PROPOSED DRAFT GLOBAL TECHNICAL REGULATION (GTR)  
on  
PEDESTRIAN PROTECTION.

This document is a working document circulated for discussion and comments. It is only submitted with the intention to facilitate discussion by the GRSP Informal Group.

Wording added in blue are comments from OICA

Wording added in red are comments from EU

[Figure 13a: windscreen rear reference line](#)

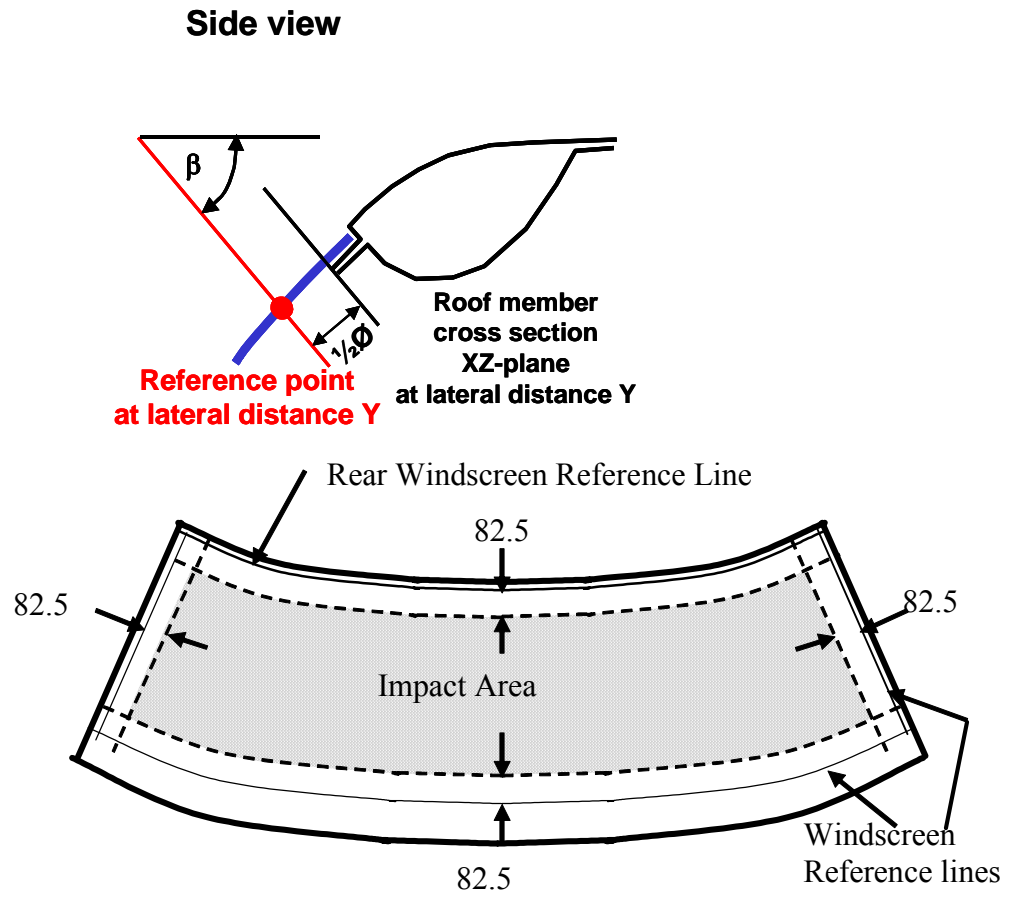
EU Comment: This diagram requires more discussion and agreement.

Figure 13b: windscreen side reference line

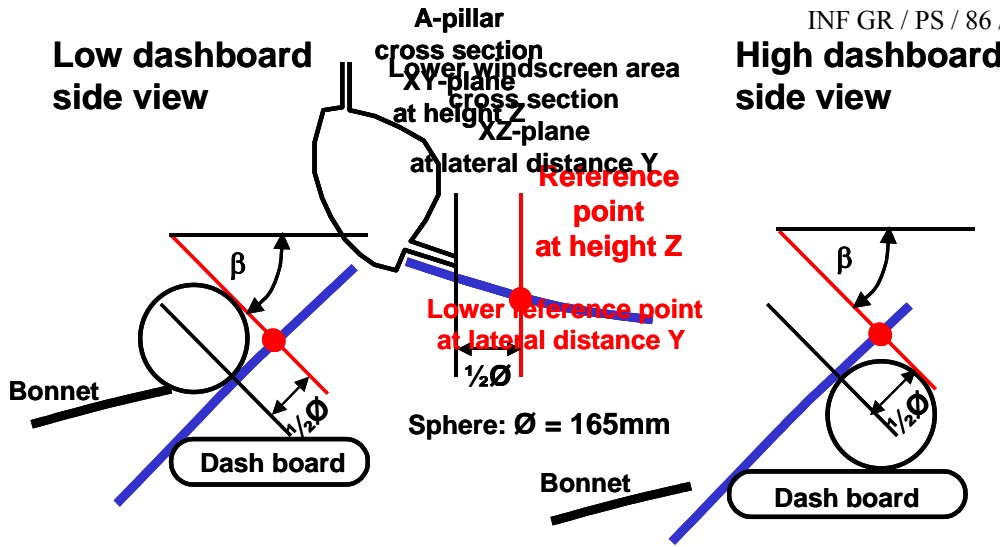
EU Comment: This diagram requires more discussion and agreement.
